**Case No. 13-0598-EL-REN
Snoddy Field
Staff Interrogatories – Initial Set**

Summary: Reply Reply to staff Inquiries case 13-0598-EL-REN Snoddy Field electronically
filed by Mr. Keith A Snoddy on behalf of Snoddy, Keith Alan Mr.

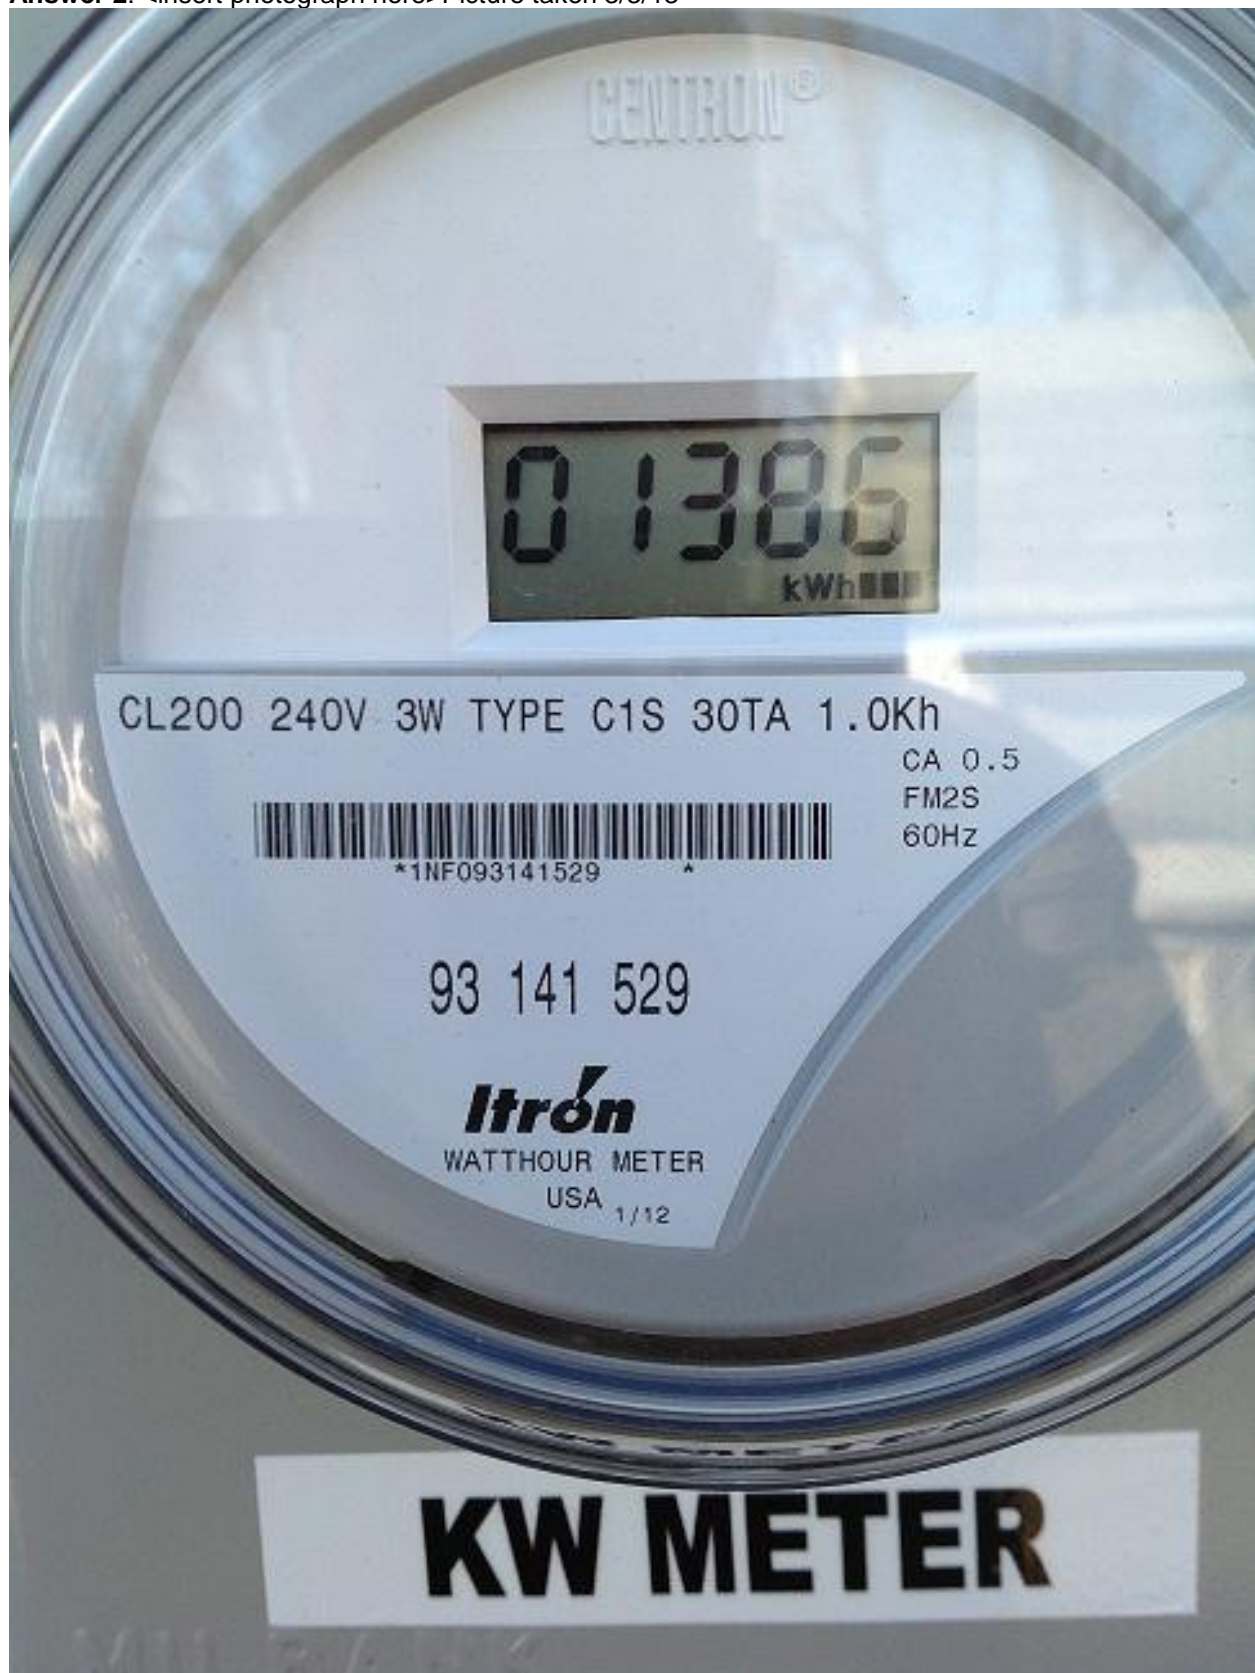
Question 2: In Section N.1e of the application, the photograph of the meter submitted does not clearly show the Serial Number and other details regarding the Make and Type of the meter.

Please submit a **clear** photograph of the meter that shows the above details and the date the photograph was taken.

Answer 2: <insert photograph here>Picture taken 3/3/13
